Access Compliance Report Public Rights-of-Way (Curb Ramps)

Main Street: BRIOSO_ST Cross Street: BRIOSO_ST Location: NE

ADA ID: RPRK211118124141 Ramp Type: Type 4 - Parallel Initial Pass/Fail: Fail Overall Compliance: No Severity Score: 2

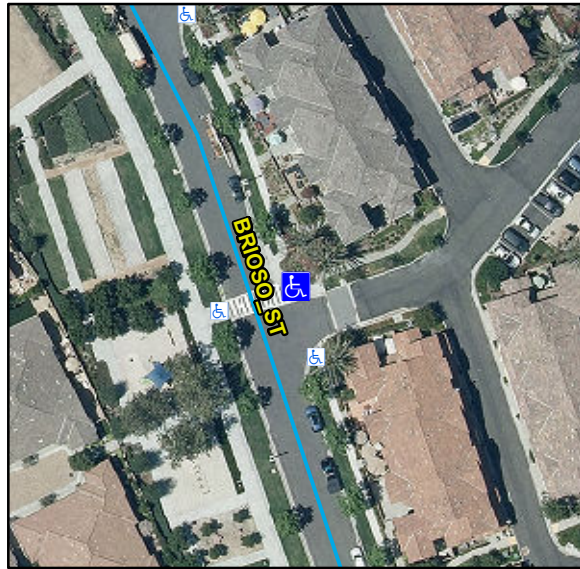
Compliance	Description	Data	Compliance	Description	Data
N/A	Ramp Length LT (in)	114	N/A	Ramp Length RT (in)	114
Yes	Ramp Width LT (in)	53	Yes	Ramp Width RT (in)	53
Yes	Ramp Run Slope LT (%)	3.9	Yes	Ramp Run Slope RT (%)	6.2
Yes	Ramp Cross Slope LT (%)	0.6	No	Ramp Cross Slope RT (%)	2.7
N/A	Landing Present	N/A	N/A	DWS Provided	N/A
N/A	Landing Length (in)	N/A	N/A	DWS Contrast	N/A
N/A	Landing Width (in)	N/A	N/A	DWS Length (in)	N/A
N/A	Landing Run Slope (%)	N/A	N/A	DWS Full Width	N/A
N/A	Landing Cross Slope (%)	N/A		DWS Offset Type	N/A
N/A	Landing Movement Obstructed?	N/A	N/A	DWS Offset Left (in)	N/A
	Landing Movement Type	N/A	N/A	DWS Offset Right (in)	N/A
N/A	Landing Shared	N/A			
N/A	Clear Space	Yes			
N/A	Clear Space To Crosswalk (in)	N/A			
N/A	Marked Crosswalk 1	Yes	N/A	Marked Crosswalk 2	No
	Crossing 1 Direction	W		Crossing 2 Direction	S
	Marked Crosswalk 1 Width (in)	144		Marked Crosswalk 2 Width (in)	N/A

Remove & Replace Curb Ramp With Two New Directional Ramps or Equivalent.
